***Paul M. Blanch***  
***Energy Consultant***

30 November 2016

Rao Tammara  
USNRC  
Washington DC

**From NRC Regulatory Guide 1.91, Rev. 2, April 2013**

ALOHA calculated blast radius for 339,000 pounds/min release rate

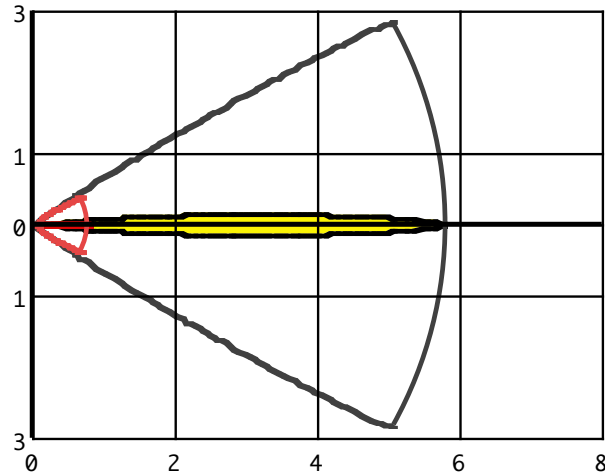
As a cross check, I also ran the unapproved ALOHA program for a single ended pipe break<sup>1</sup> and we can see below the high risk areas range from **4200 feet all the way to 5.8 miles**, somewhat higher than the NRC's calculations of 1100 feet. The actual flow rate for a double ended break would be much greater and but not inconsistent with the NRC's calculated value of 376,000 kg/minute, a number also provided by FOIA. ALOHA may or may not be correct but it does project a blast radius similar to the engineering calculations.

The bottom line is that we have three professional engineers using a QA program and a physical scientist running calculations without any guidelines, procedures, reviews or approvals. The engineers project a blast radius in the range of 4200 feet and confirmed by ALOHA using a single ended break. You calculated a blast radius of about 1100 feet. Why the very significant difference? Claiming "Regulatory Infallibility" will not suffice.

***Red : 1401 yards=4200 feet --- (30000 ppm = 60% LEL<sup>3</sup> = Flame Pockets).***

***Yellow: 5.8 miles --- (5000 ppm = 10% LEL)***
